PLANNING AND DEVELOPMENT SERVICES STAFF REPORT

**SUBJECT: 278-280 Collingwood Site Plan for City Council Approval
(278-280 Collingwood Drive)
File No. SP13-059**

UPDATED STAFF REPORT

SHEET TITLE
LANDSCAPE PLAN

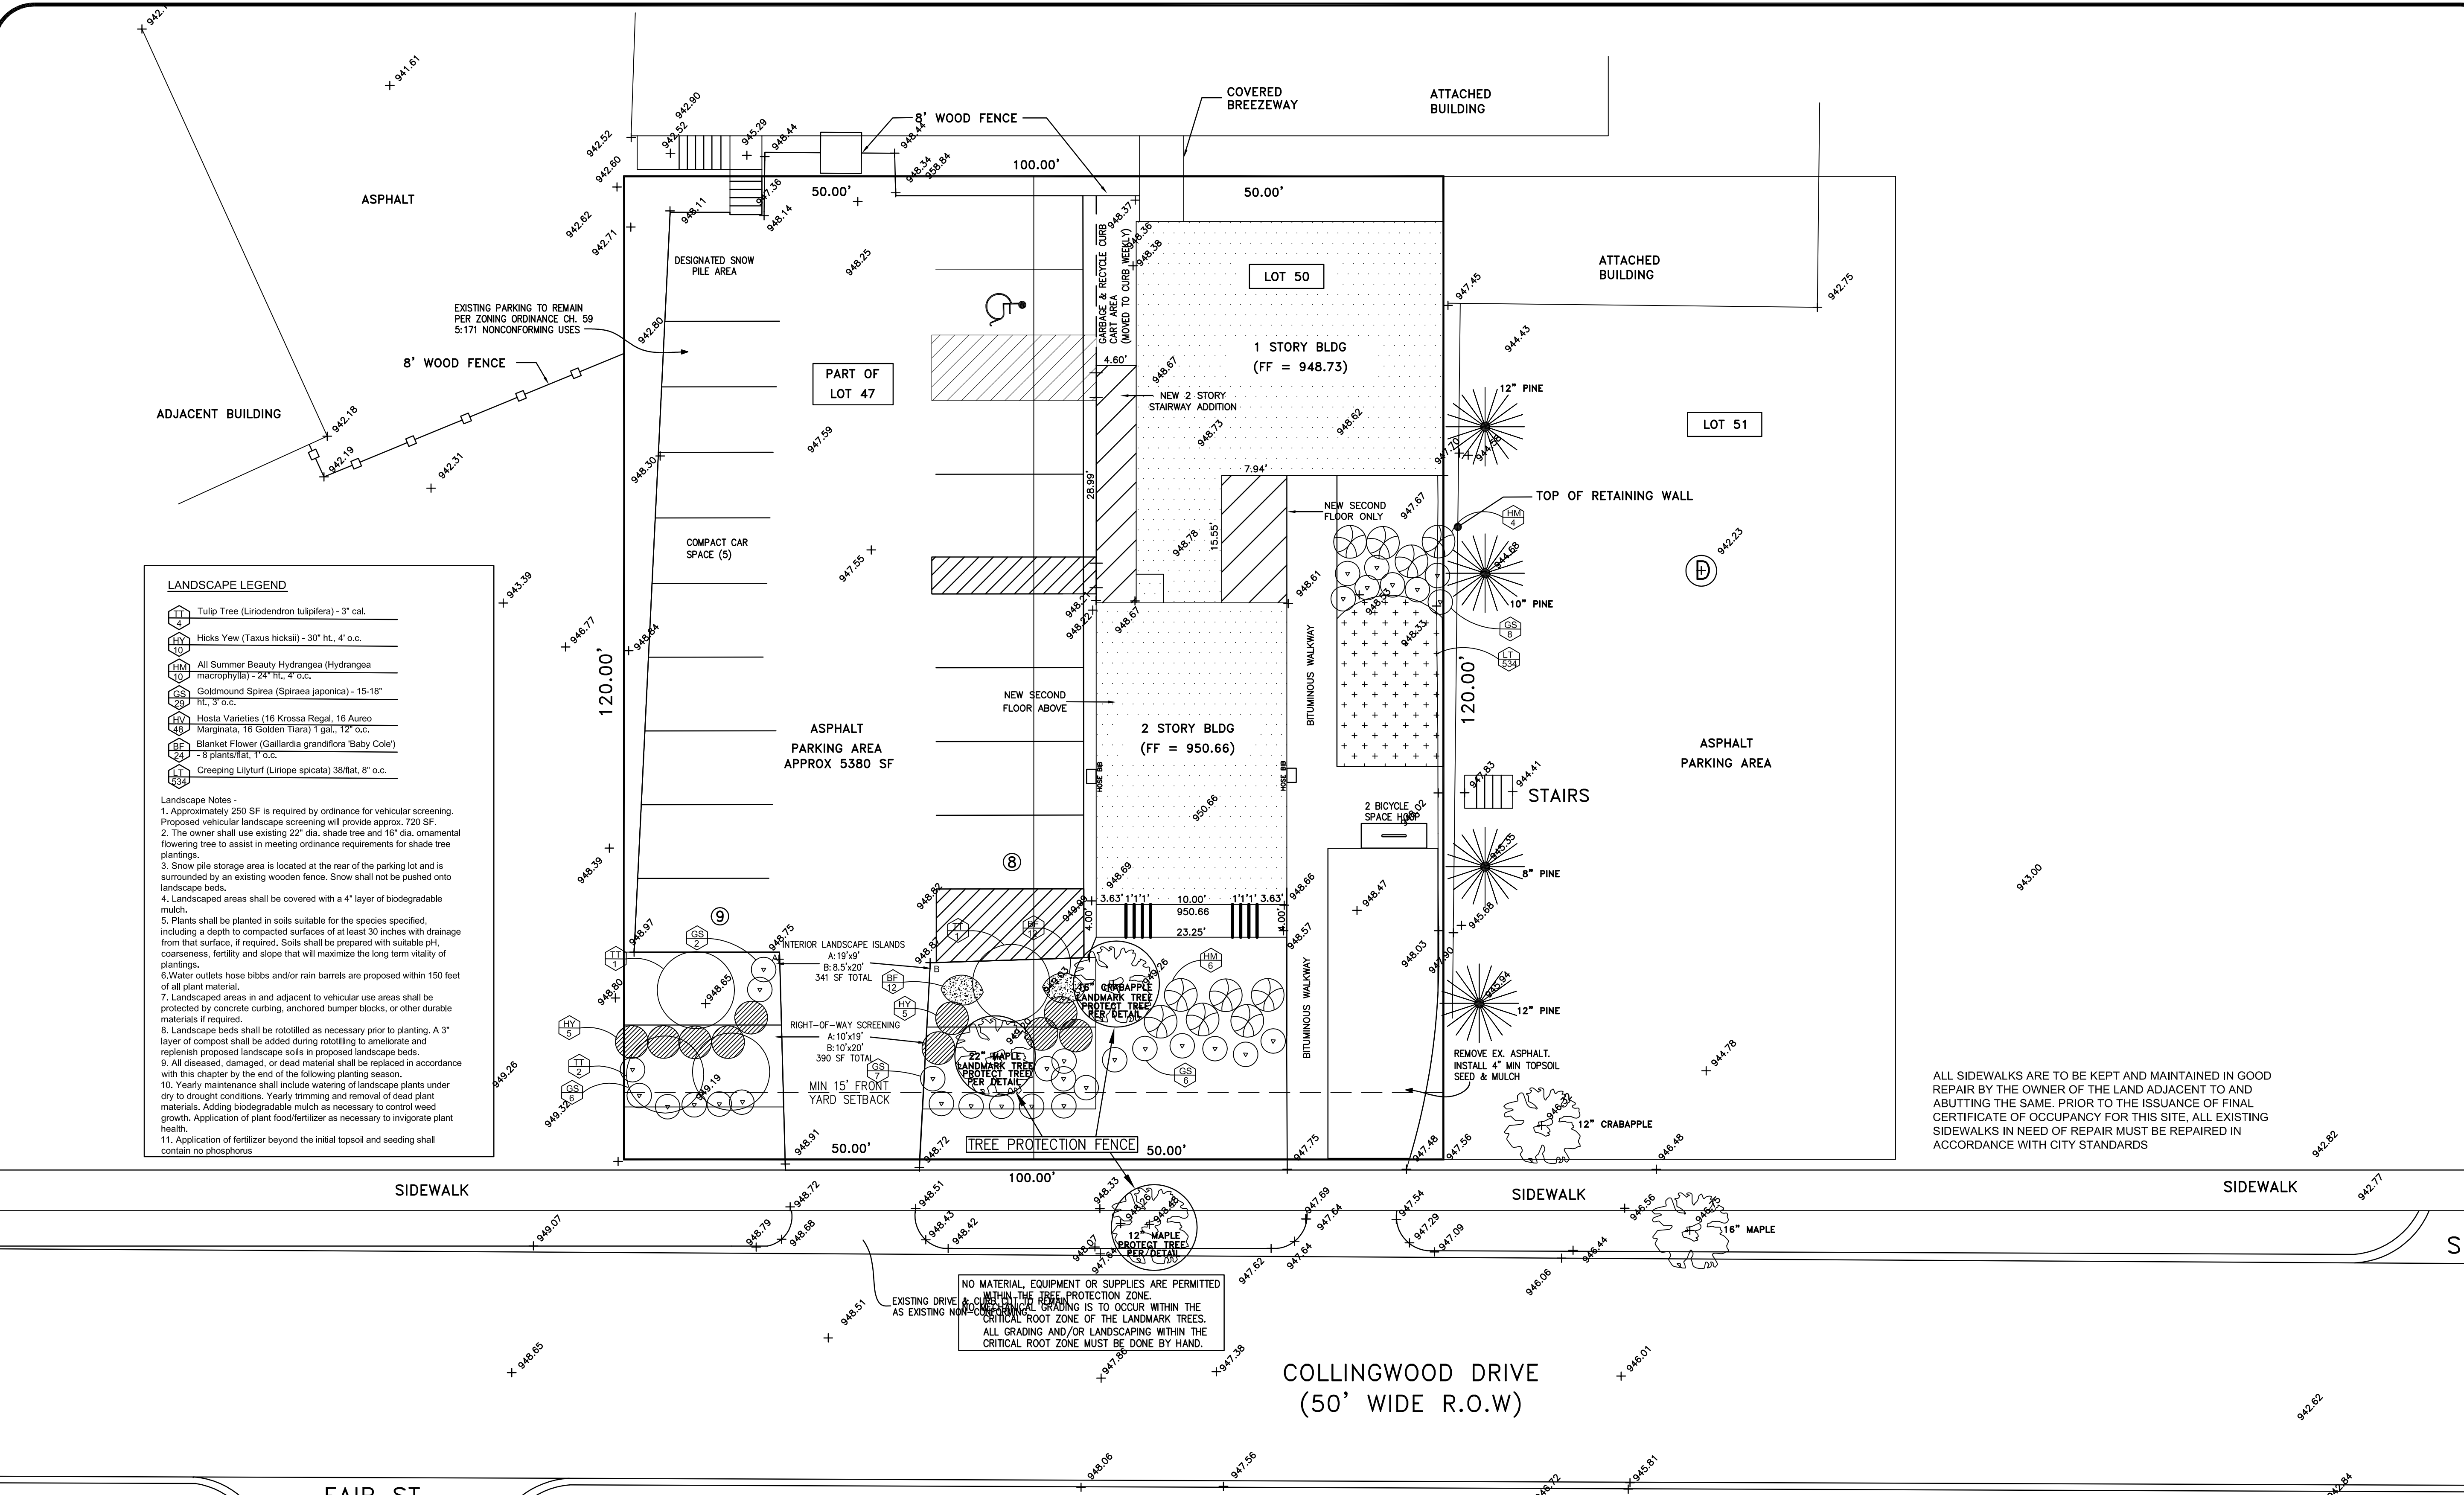
After the staff report for this project was completed for the packet, Planning received comments from the Urban Forest and Natural Resource Planning Coordinator that the required shrubs for the right-of-way buffer and the required tree for the interior parking landscaping should not be planted in the critical root zone of the two landmark trees located at the northeast corner of the parking lot. As suggested by staff, the petitioner submitted a Landscape Modification request to relocate these proposed plantings from the critical root zones of the trees and to areas south of the driveway and along the edge of the proposed entry walkway to this site.

The landscaping proposed for the right-of-way screening and the tree required for the interior parking lot landscaping requires planting in the critical root zone of two existing landmark trees, which would damage the root systems.

There is landscaping proposed to meet the requirements where feasible without damaging the critical root systems of the existing landmark trees, namely on the south side of the existing driveway along the proposed walk, and along the northern property line where existing pavement is being removed.

Systems Planning – Urban Forest and Natural Resource Planning – Staff supports the landscape modification request submitted by the petitioner to waive the required interior landscape and right-of-way landscaping requirements in the area north of the southern curb cut to protect the two landmark trees located in this area. The majority of trees roots are within the first 18-inches of the soil and the planting of landscaping within the critical root zone of these landmark trees can damage the root system and adversely affect the health of these trees. The petitioner is proposing more trees and shrubs in the right-of-way buffer on the south side of the driveway than are required.

The Ann Arbor City Planning Commission hereby recommends the Mayor and City Council approve the proposed landscape modifications according to Chapter 62 (Landscape and Screening Ordinance), Section 5:608 (1)(a), subject to planting of the required landscaping materials in alternative locations, as recommended by the Urban Forest and Natural Resources Planning Coordinator.

Staff recommends that the proposed landscape modification be **approved** because the changes are consistent with the intent of the ordinance and protect the health of the existing landmark trees.
